TOWN OF EXETER, NEW HAMPSHIRE

PUBLIC NOTICE EXETER CONSERVATION COMMISSION Site Walk

**TOWN OF EXETER
PLANNING DEPARTMENT MEMORANDUM**

Date: October 31, 2024
To: Technical Review Committee
From: Kristen Murphy, Conservation & Sustainability Planner
Subject: Riverwoods Supportive Living Health Center, PB 24-16

L-1
Sheet 1 of 1

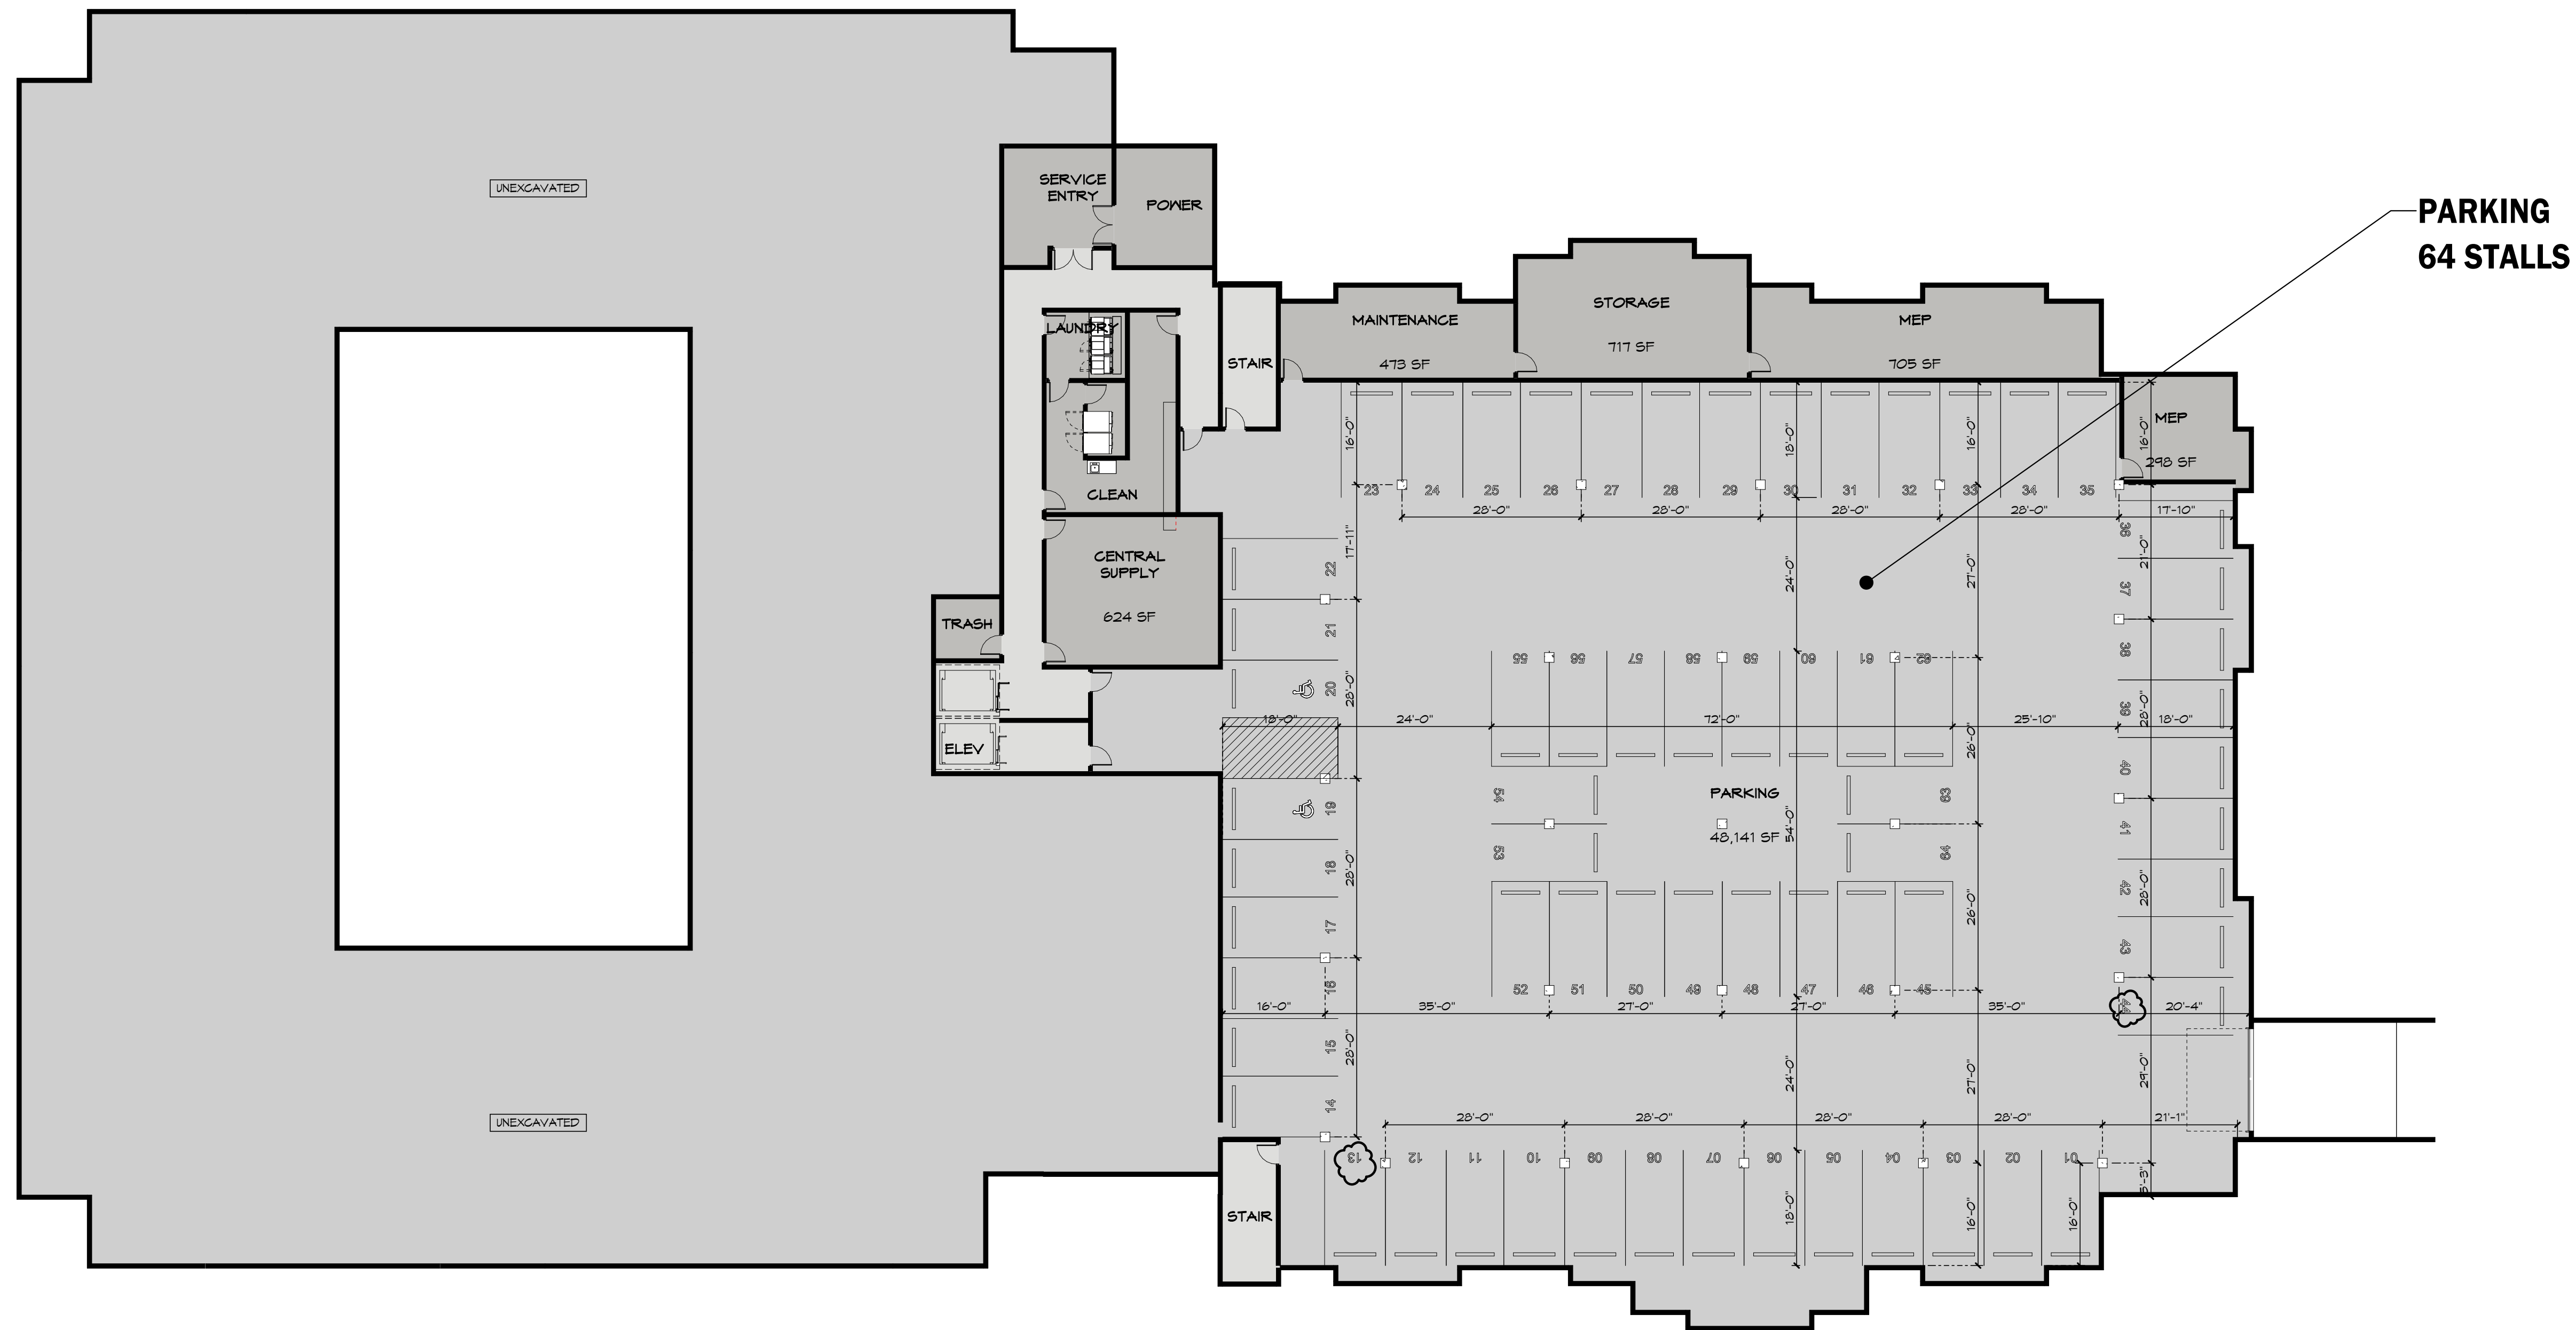
- I commend the effort and attention given to incorporating native plantings in the landscape plan for this project.
- Given the amount of direct wetland and wetland buffer impact a natural resource plan seems warranted for this project (Site and Sub 7.12). Recommend consulting and aligning with documents previously prepared for Riverwoods Ridge/Boulders developments.
